DSOX4052A-01

S E R V I C E N O T E

4000 X-Series Scopes

A replacement of the power supply cover is needed when the cabinet assembly is replaced.

New revision cabinet assembly (54709-64401)

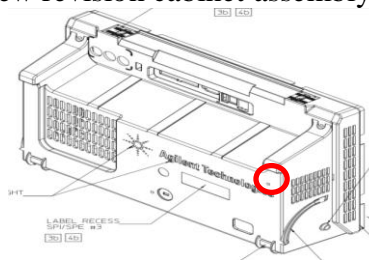
If the cabinet assembly requires a replacement, also replace the power supply cover in order to become compatible with the new revision of cabinet assembly and become compatible with zipper pouch attachment.

1. If the cabinet assembly (54709-64401) needs to be replaced, check if it is the old revision or the new revision
 - a. Old revision has 3 screw holes
 - b. New revision has 4 screw holes

2. If the cabinet assembly is the new revision, proceed with repair as normal
3. If the cabinet assembly is the old revision
 - a. Replace the power supply cover (54695-00103) with new revision
 - b. Replace cabinet assembly as usual (54709-64401)
 - c. Insert screw (0515-0380) into the new screw hole on the cabinet assembly (circled below)
